NUMBER: 19-005-04 REV. A

GROUP: Steering

DATE: October 25, 2004

Pop/Tick/Creak Sound In Steering Column

Fig. 1 **WAVE WASHER, SHIM, AND LOWER BEARING WEDGE INSTALLATION******

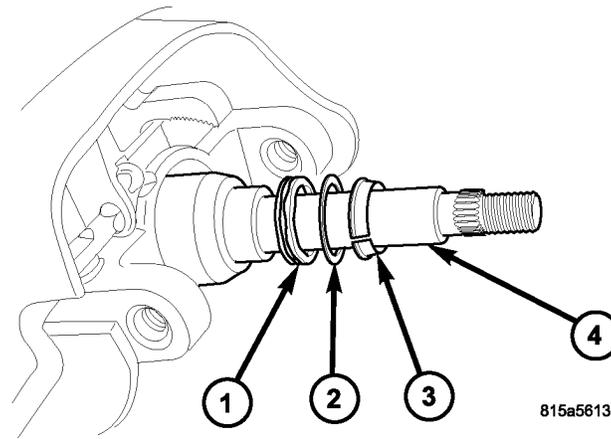
THIS BULLETIN SUPERSEDES SERVICE BULLETIN 19-005-04 DATED MAY 25, 2004, WHICH SHOULD BE REMOVED FROM YOUR FILES. ALL REVISIONS ARE HIGHLIGHTED WITH **ASTERISKS**** AND INCLUDES A REVISED FIGURE 1 AND STEP 16 OF THE REPAIR PROCEDURE.**

- 1 - ****WAVE WASHER (REUSE THE ORIGINAL)****
- 2 - ****SHIMS (2)****
- 3 - LOWER BEARING WEDGE
- 4 - STEERING SHAFT
